ADDENDUM # 4

Project	TA Blakelock High School Renovations	Project No.	2215-C
Location	1160 Rebecca Street, Oakville, ON	Date of Issue	2025 05 02
Owner	Halton District School Board	File	2215/7.1.3

This Addendum forms part of the Contract Documents and amends the original Drawings and Specifications, dated 2025 04 17, and all preceding Addenda, as noted below.

3 FLOOR FINISH PLAN
A101 1:50

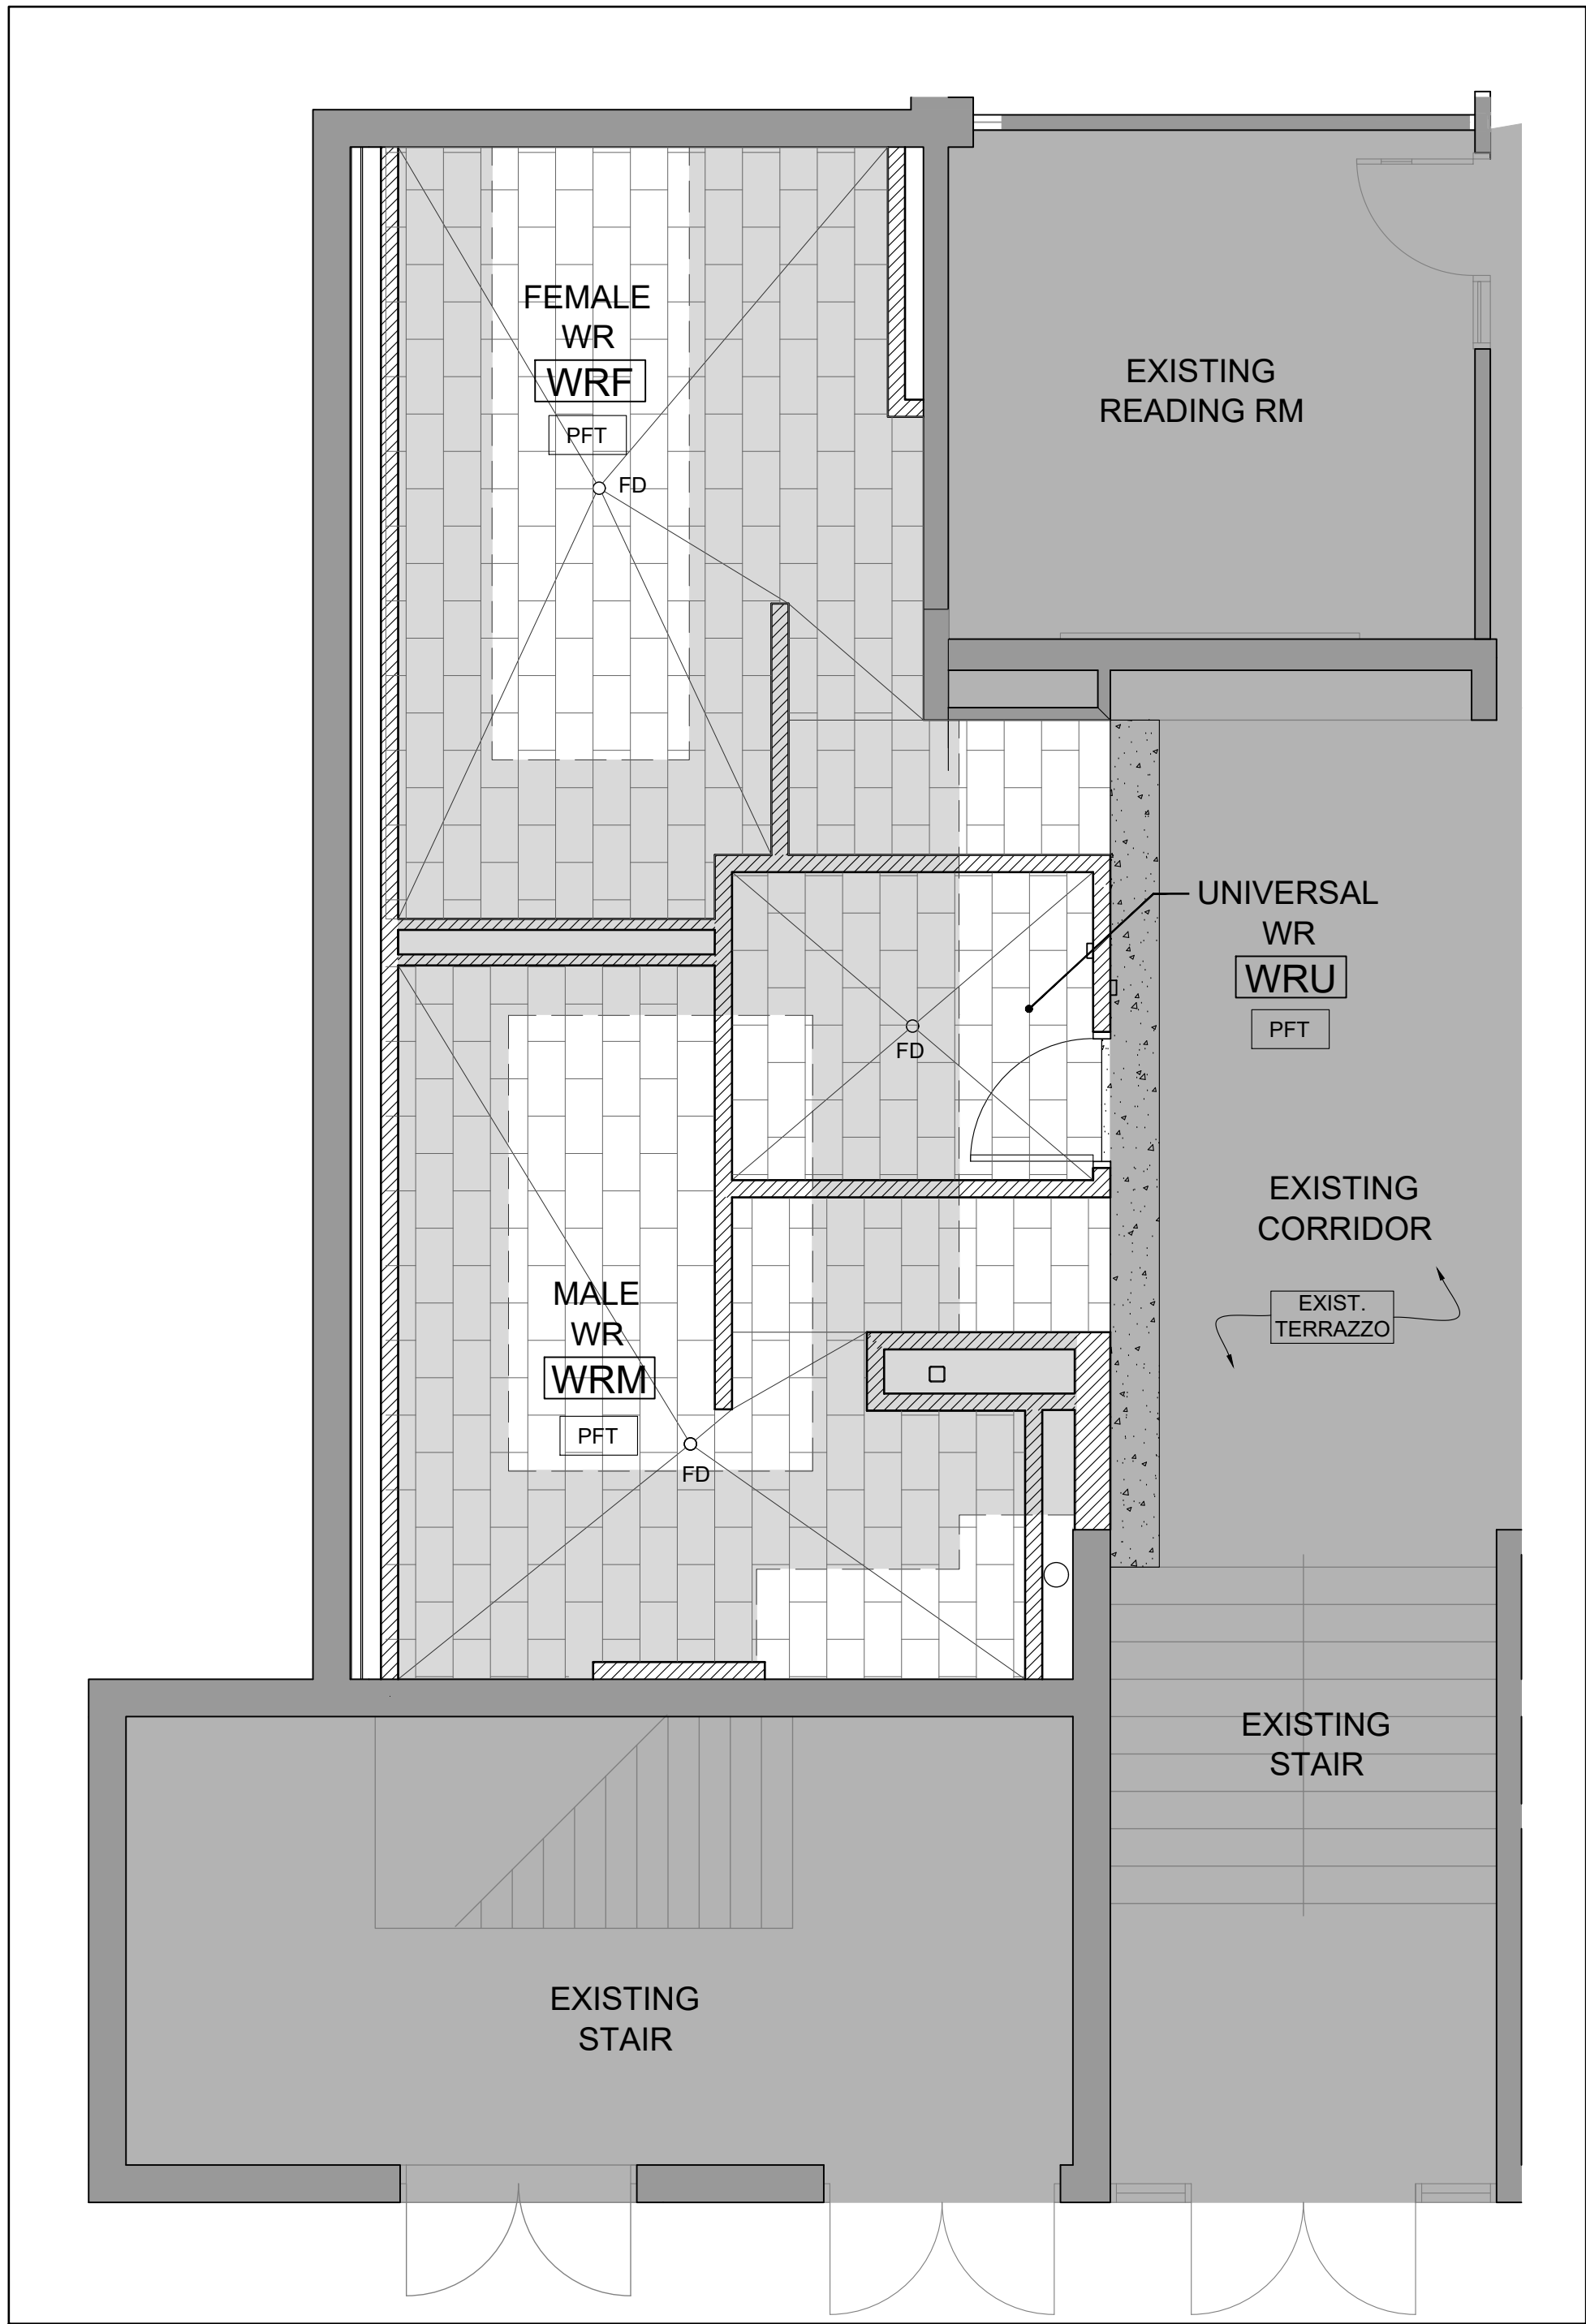
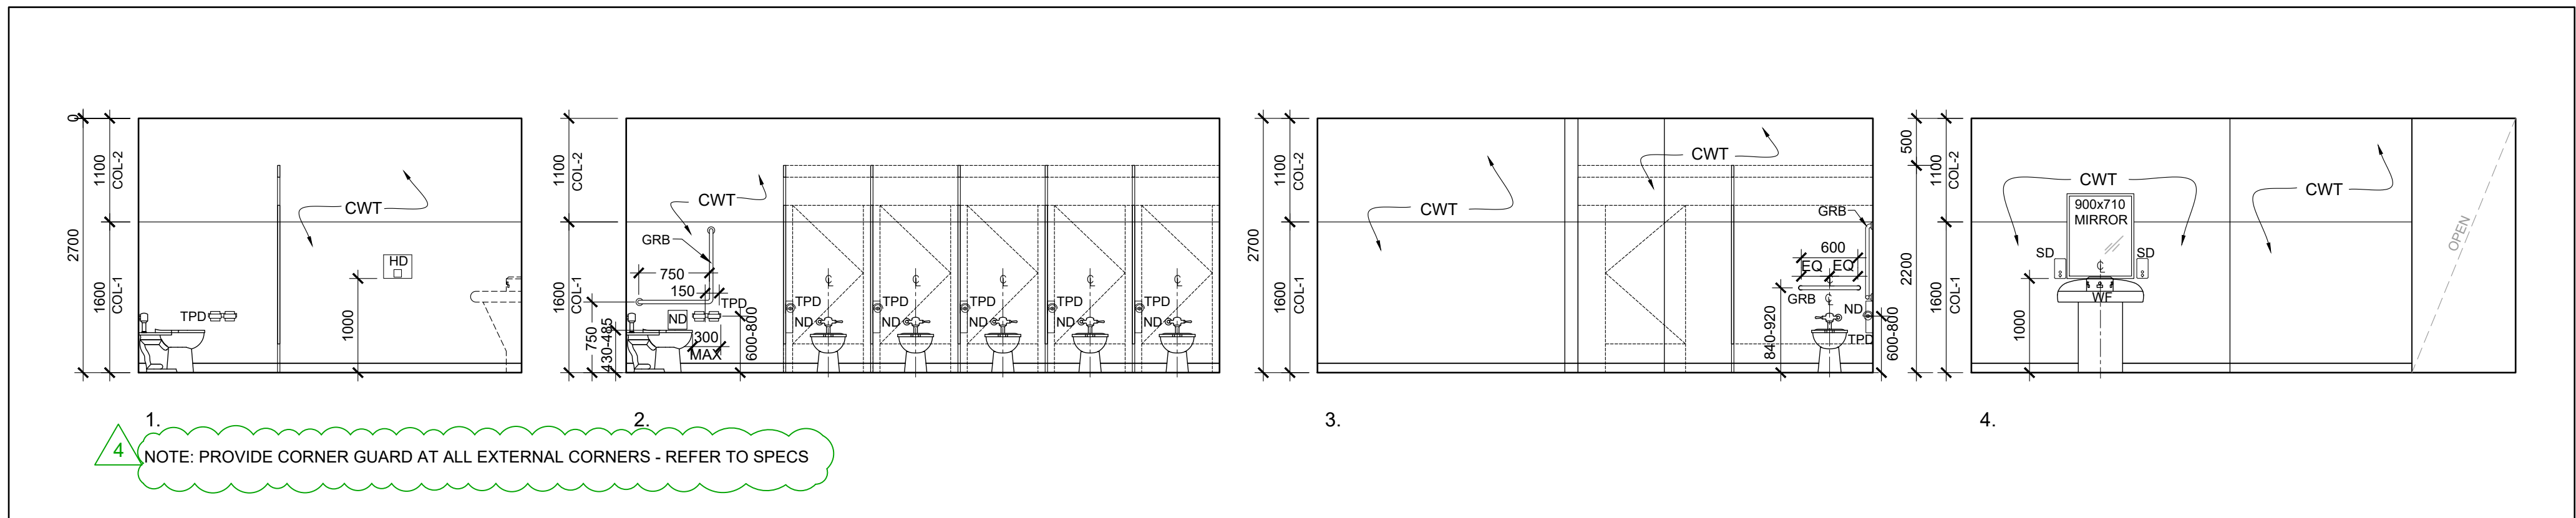
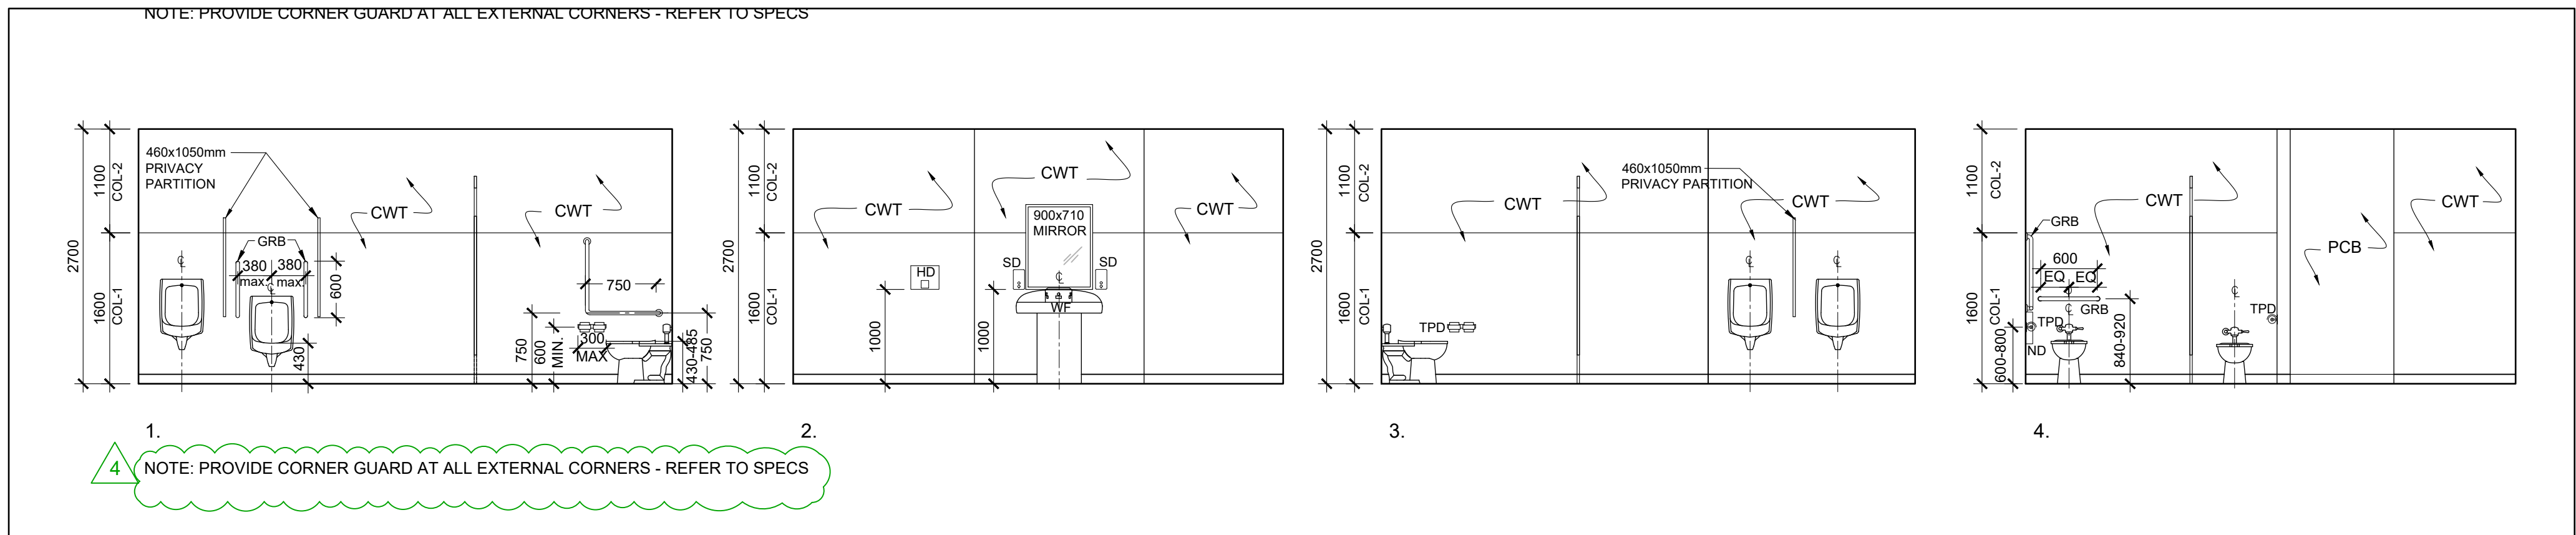
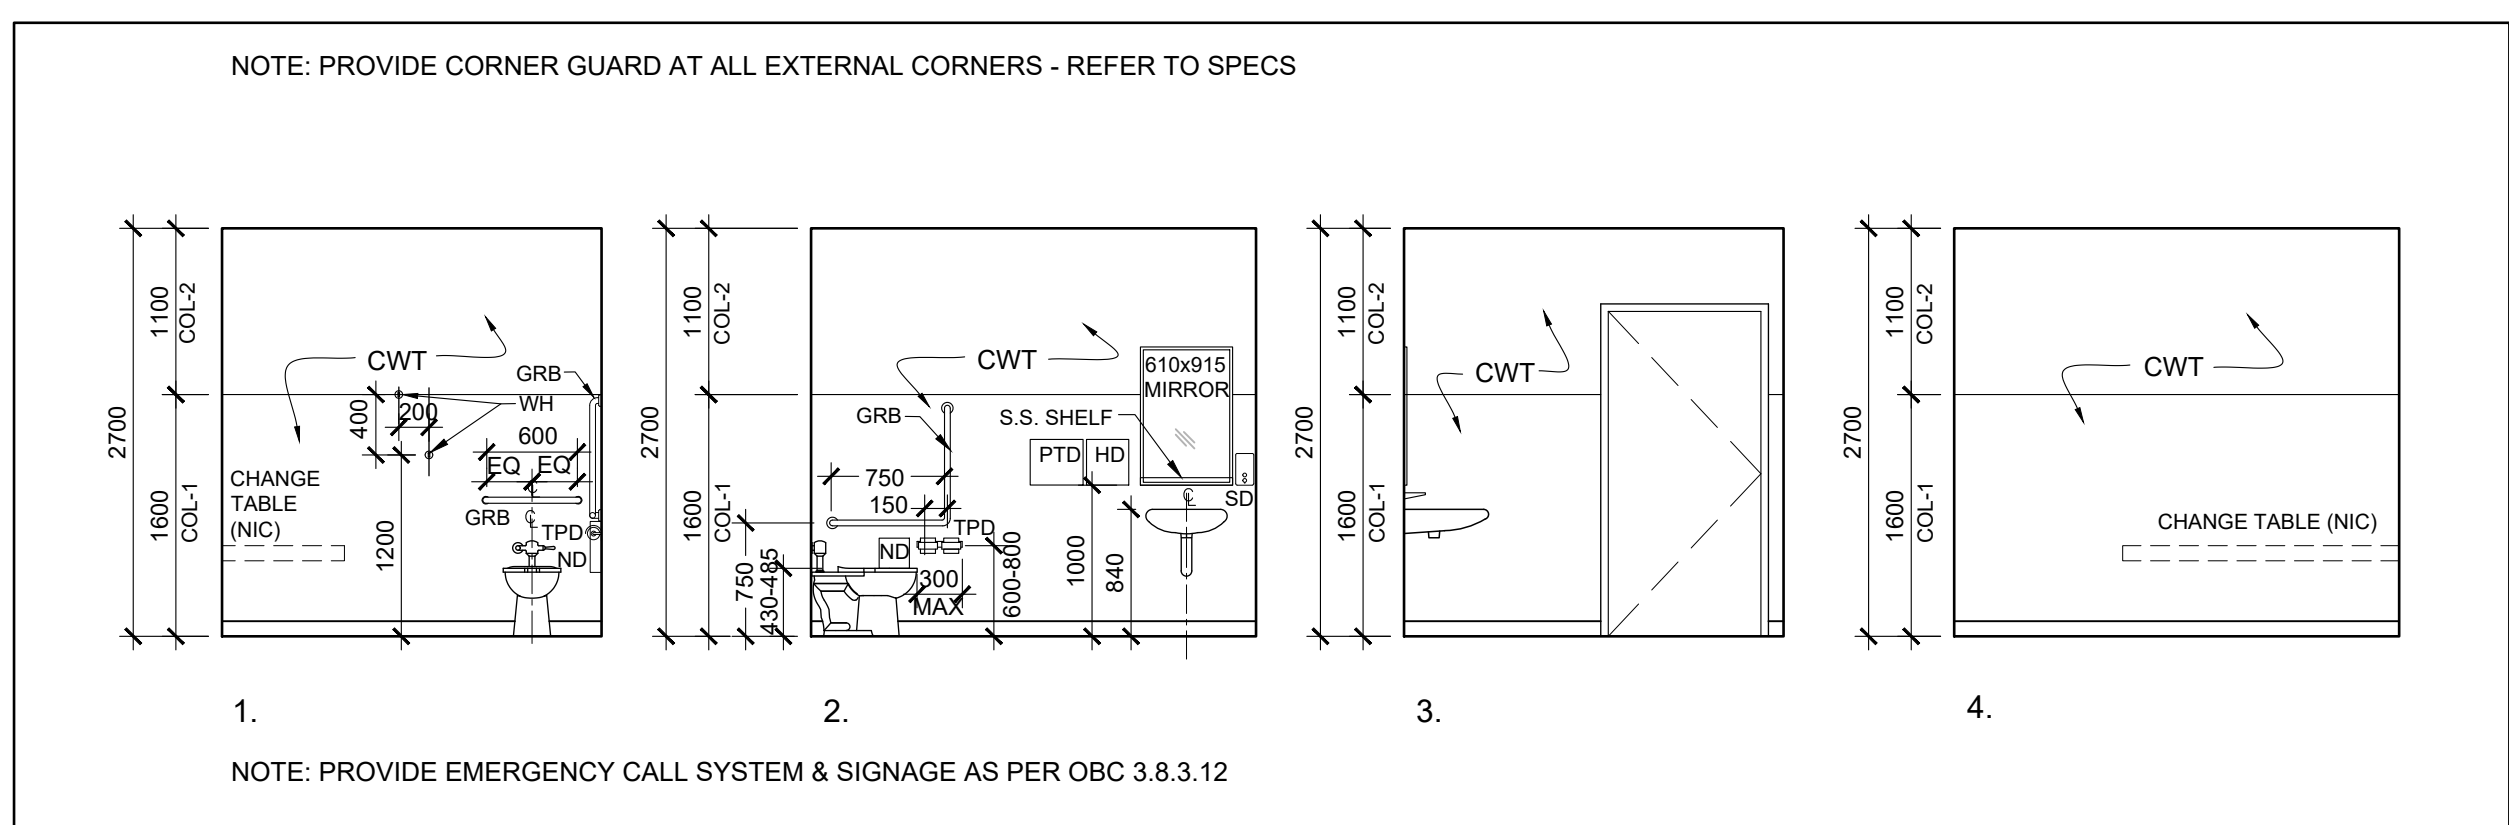
- .1 Re-issued drawing with additional notes
